Re: Tract H Sawmill
1921 Bellamah Ave NW
Traffic Circulation Layout
Engineer's Stamp 07-06-22 (J13-D017B)

Based upon the information provided in your submittal received 09-06-22, the above referenced plan cannot be approved for Building Permit until the following comments are addressed:

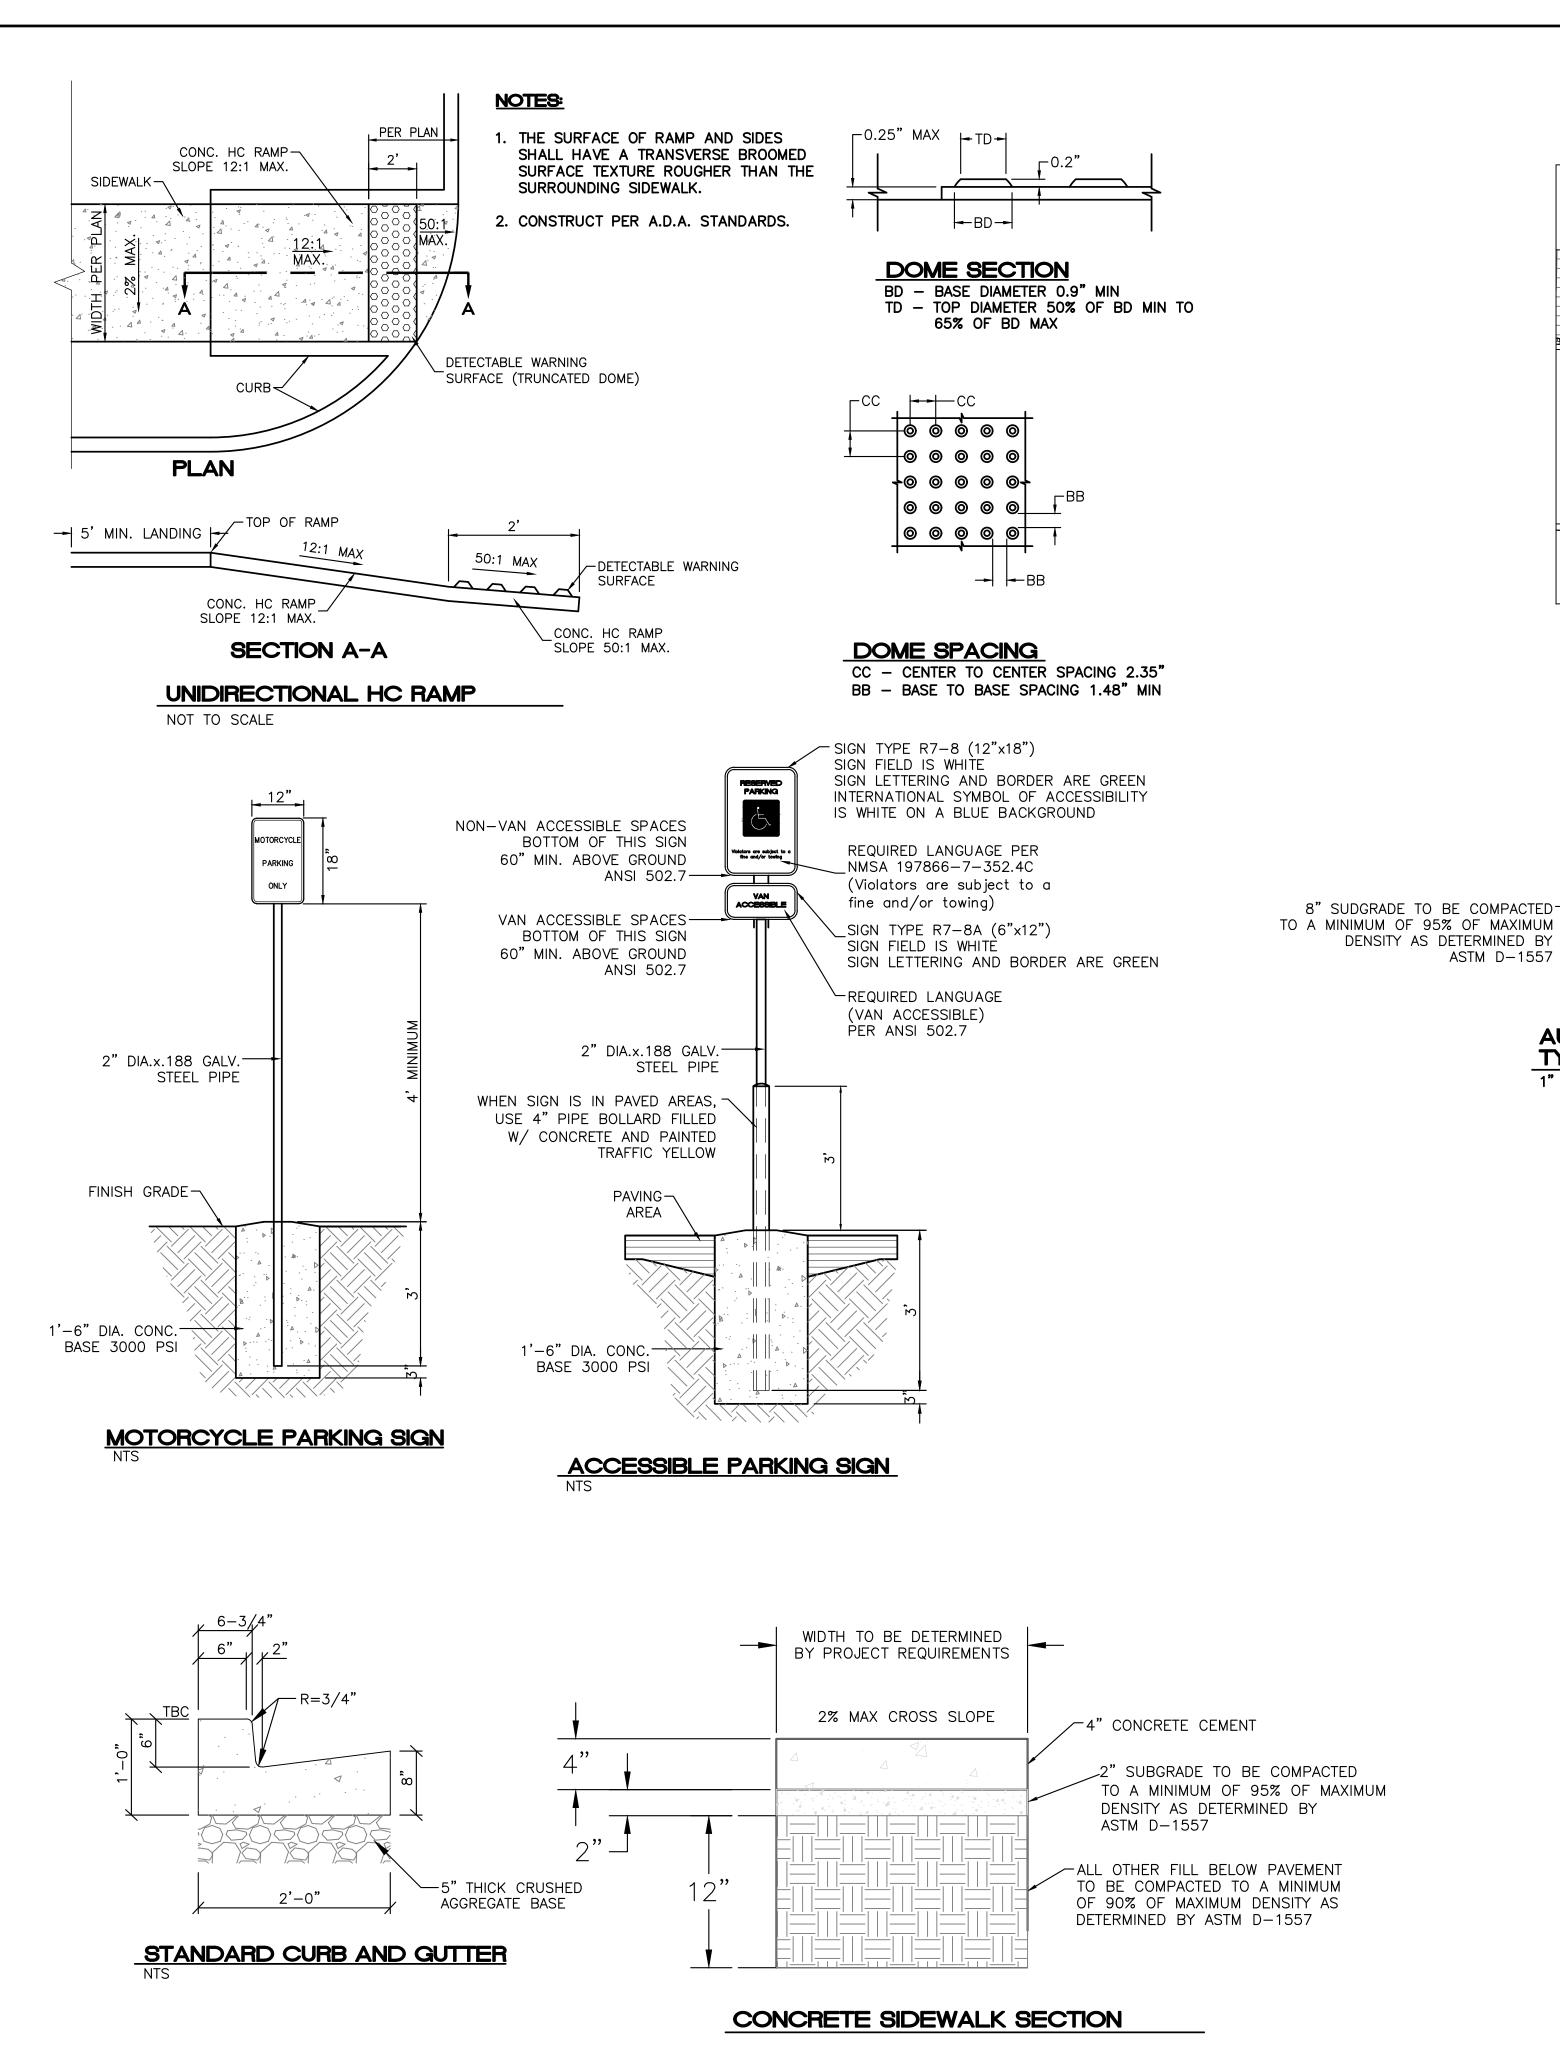
- Site Access: please provide Curb Return design for the driveways access off Bellamah Ave. and reference COA std dwg. 2426. Also, the One Way drive (Exit Only) shall have "Do Not Enter" signage and pavement marking. Please provide details for signage and pavement marking. Please note that the GIS shows there are two existing curb return driveways access.

- 2. Please reconfiguration parking spaces layout. The parking layout should provide continuous flow of traffic through the lot.
  - 3. ADA curb ramps must be updated to current standards and have truncated domes installed.

- 4. Per the IDO, a 6 ft. wide ADA accessible pedestrian pathway is required from the public sidewalk to the building entrances. Please clearly show this pathway and provide details.

- 5. Per DPM, a 6 ft. wide ADA accessible pedestrian pathway is required from the ADA parking stall access aisles to the building entrances. Please clearly show this pathway and provide details.

- 6. Define ADA pathways by labeling of ramps, flush pavement, dimensioning of pathways, doorways, etc.
  - 7. ADA accessible pedestrian pathway should not be placed behind parking space or adjacent to a vehicular way. Vehicle and pedestrian/wheel chair conflicts should be avoided as much as possible.

- 8. Parking areas shall have barriers to prevent vehicles from extending over public sidewalk, public right-of-way, or abutting lots.
  - 9. Refuse vehicle maneuvering shall be contained on-site. The refuse vehicle shall not back into the public right of way. provide a copy of refuse approval.

- 11. It is not apparent what type of pavement surface is being proposed. A hard driving surface will be required as part of this proposed project for parking area and drive aisles.

- 12. Please specify the City Standard Drawing Number when applicable.
- 13. Add a note stating "All broken or cracked sidewalk must be replaced with sidewalk and curb & gutter." A build note must be provided referring to the appropriate City Standard drawing.
